FROM CONTRACTOR: Cardinal Contr. Co.
 TO: Lockwood Greene, Engrs.
 PROJECT TITLE AND LOCATION: NAVAL REGIONAL MED. CTR., Camp Lejeune, N.C.

ITEM NO.	PROJ. SPEC. SECT. & PARA. and/or PROJ. DWG. NO.	ITEM IDENTIFICATION (Type, size, model no., Mfg. name, dwg. or brochure number)	NO. OF COPIES	ACTION CODES	REVIEWER'S INITIALS	DATE
555-D 556-D 556-1B		SECO Conveyor Drawings for Clarification - #1, dated 10/28/80; #2, dated 2/4/81	7	RSC	AN	4-13
" "		Somat Pulper data sheets and Dwg. E-2249, dated 10/8/79.	7	AD	AN	4/13
" "		Blakeslee Dishwasher data sheets & Dwg. 3-5033952-1-D	7	MSAO	DW

SOMAT AND HOBART WASTE PULPING SYSTEMS -
COMPARITIVE ANALYSIS OF
DESIGN, CONSTRUCTION, AND ACCESSORY FEATURES

G. S. BLAKESLEE & CO. CICERO, ILLINOIS
 MARINE CORP BASE CAMP LE JEUNE, N.C.
 DR. BY J.F.K. CHK. BY B SCALE 1/2" = 1'-0" DATE 9-14-79
 FIRST MADE FOR 3-790914-1-A MACHINE MODEL RA-PLC JK DWG. NO. 3-S033952-1-D

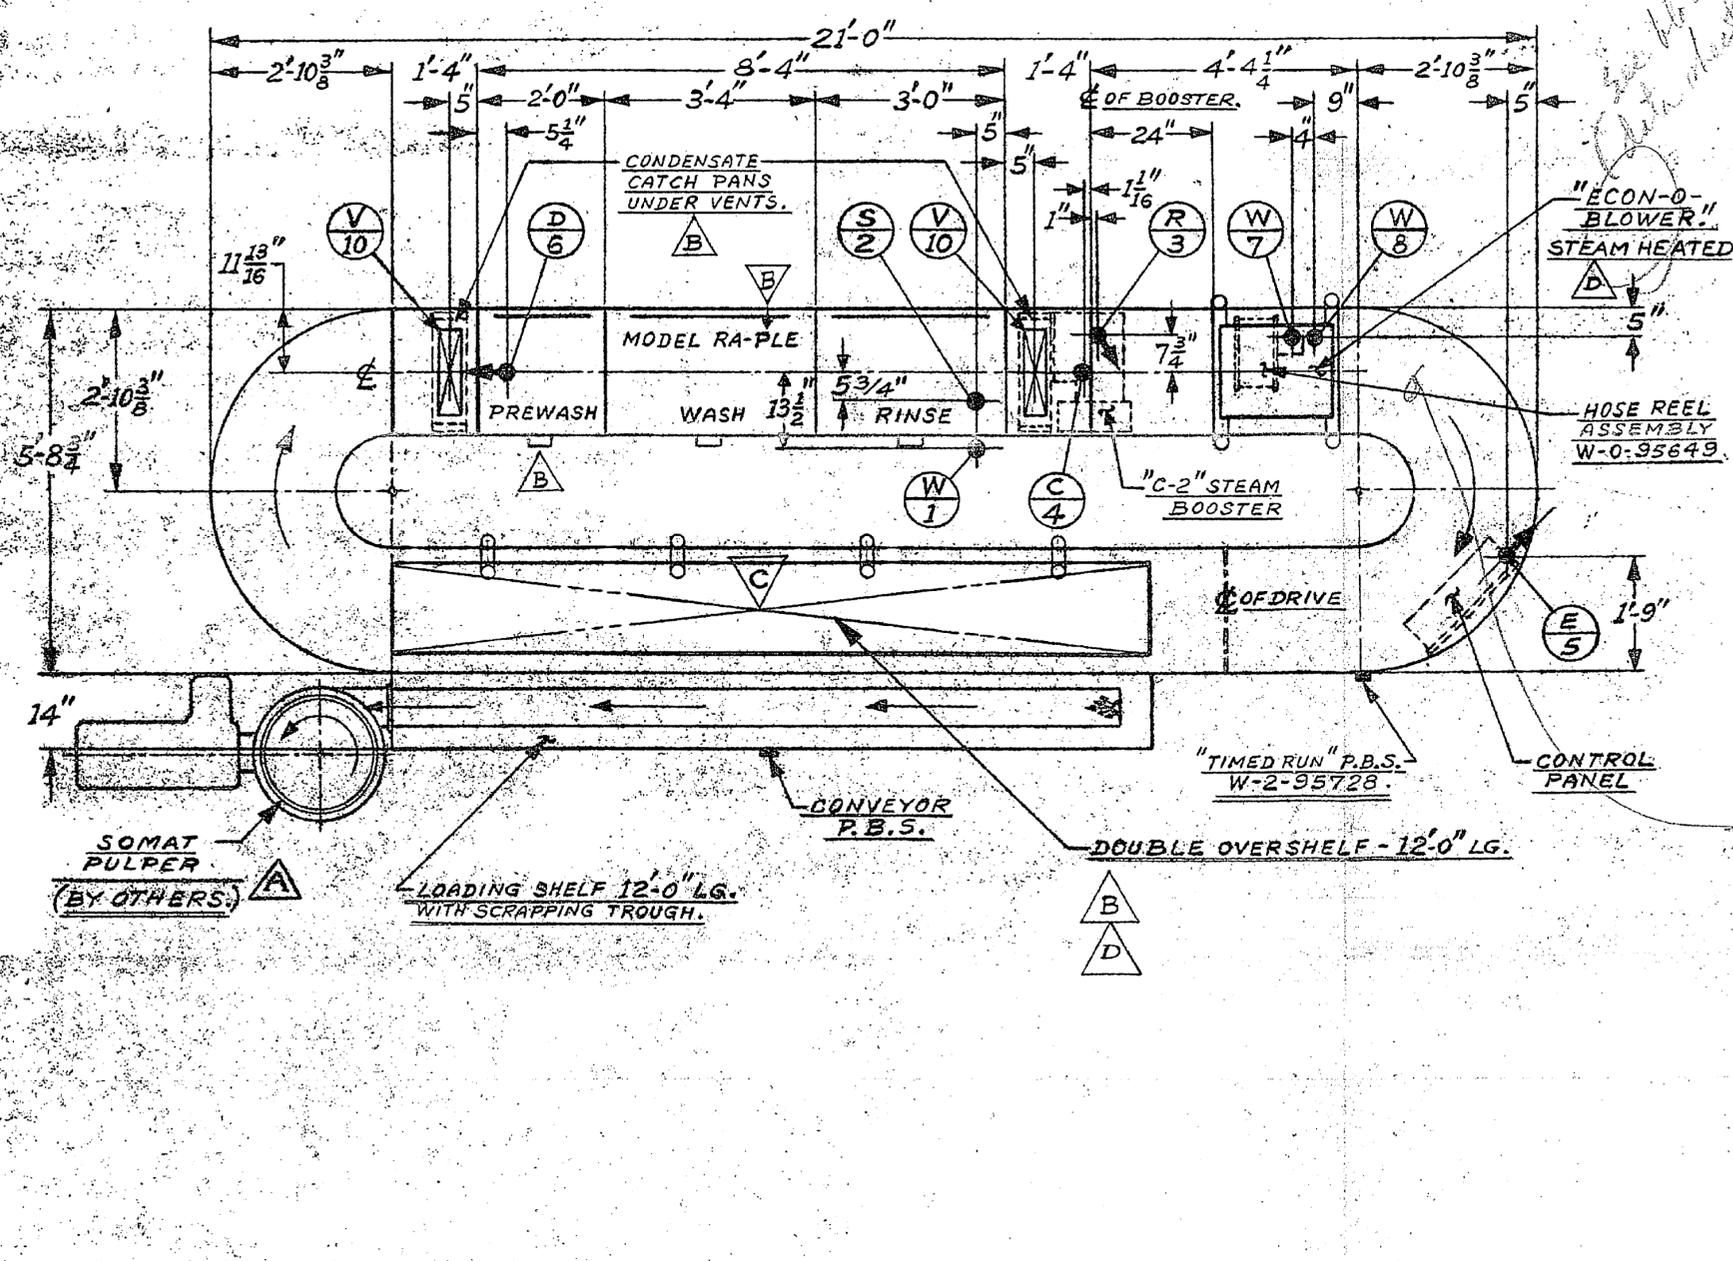
*As noted in comparative
 analysis submitted, this
 proposal does not substantially
 comply w/ contract
 requirements.*
